Subject: Inspection and replacement of spar spigot assemblies

Concerning: Model: ASTIR CS TCDS No.: 306
- Series: - S/N:
ASTIR CS 1001-1536
ASTIR CS 77 1601-1844
ASTIR CS Jeans 2001-2248
CLUB ASTIR II 5001-5061 (Suffix "C")
STANDARD ASTIR II 5001-5061 (Suffix "S")
G 102 CLUB ASTIR III 5501 & up (Suffix "C")
G 102 CLUB ASTIR IIIb 5501 & up (Suffix "Cb")
G 102 STANDARD ASTIR III 5502 & up (Suffix "S")

Model: SPEED ASTIR II TCDS No.: 320
- Series: - S/N:
SPEED ASTIR II 4001-4027
SPEED ASTIR IIB 4028-4107

Definition of the distance b

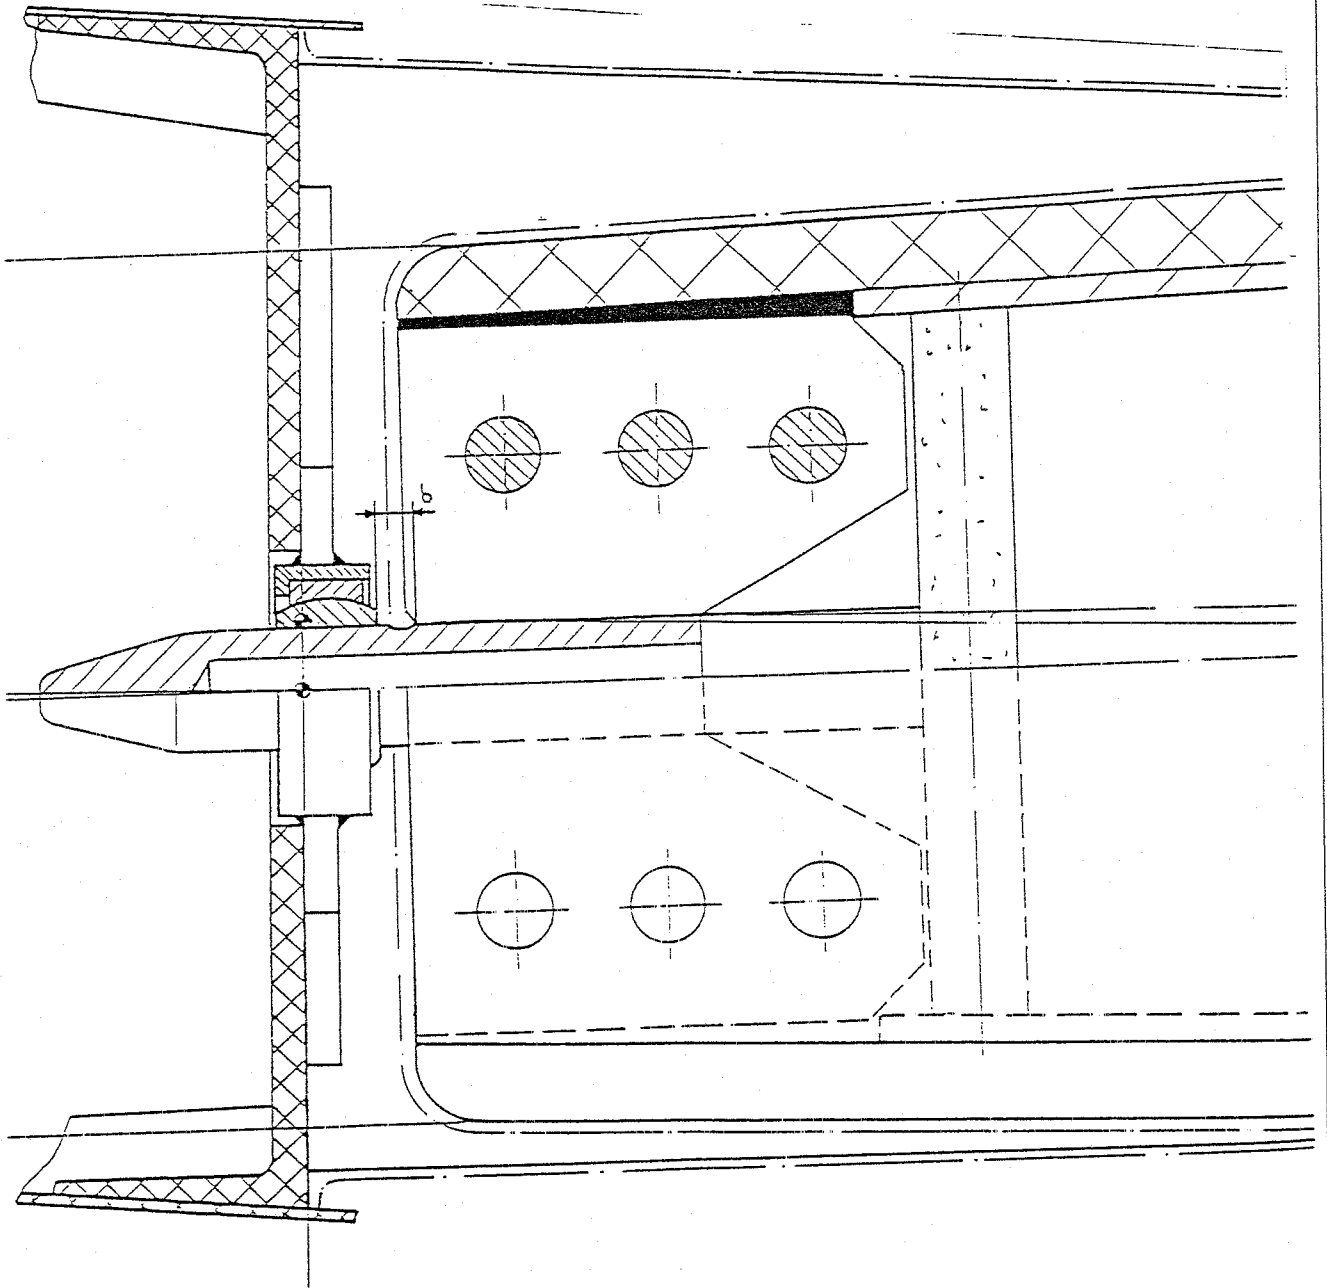
If no crack is discovered and if the distance between spigot plates and swivel bearing is (refer to figure on page 3):

- $b \leq 10$ mm: Carry out Action 2 not later than 31 December 1992
- $b > 10$ mm: Carry out Action 2 not later than 30 June 1991

If a crack is discovered and if the distance between spigot plates and swivel bearing is $b \leq 10$ mm, the crack may initially be blended out (refer to page 4 for procedure):

- Removal of crack is possible:
Carry out Action 2 not later than 31 December 1992
Warning: After blending, check that dimension b is still ≤ 10 mm.
- Removal of crack not possible:
Carry out Action 2 immediately

If a crack is discovered and if the distance between spigot plates and swivel bearing is $b > 10$ mm, Action 2 must be carried out immediately.

Comments to crack inspection

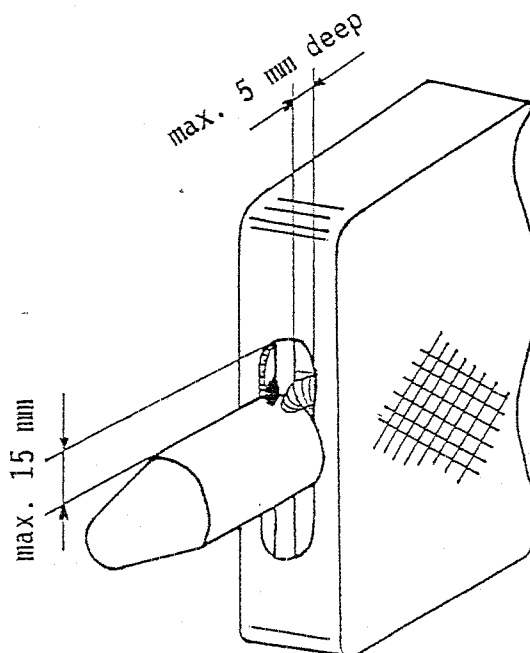
To perform the crack inspection the section of the wrapping around the main spigot has to be removed (max. 15 mm) and the adhesive material removed to expose the welding seam (max. 5 mm deep, see figure). Be very careful not to scratch or otherwise damage the spigot or plate.

If the weld seam is continuous around the plate, the complete toe of the welding seam has to be inspected. Grooves or nicks in the surface of the welding seam which are not part of a crack must be polished out and the crack inspection performed again.

Procedure for blending out a crack

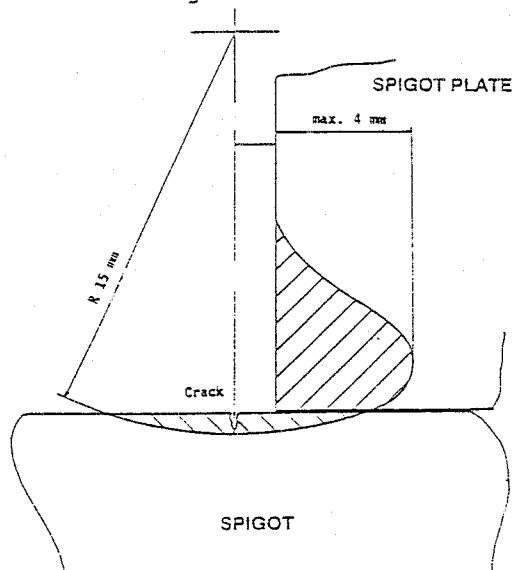
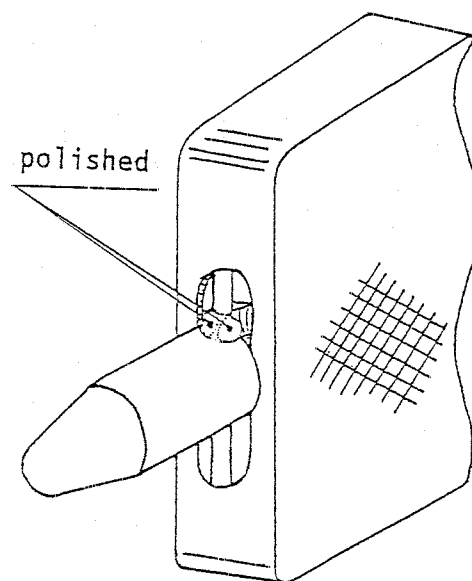
A crack may be blended out if the following conditions are fulfilled:

- * crack on one side not deeper than 0.75 mm
- * cracks on both sides not deeper than 0.5 mm each

Blending out should be done with grinding caps or equivalent. The grinded surface has to be polished.

Sketch mentioned below shows a cross section of blending out a crack.

Finally apply a coating of resin to the exposed area (wood and metal).
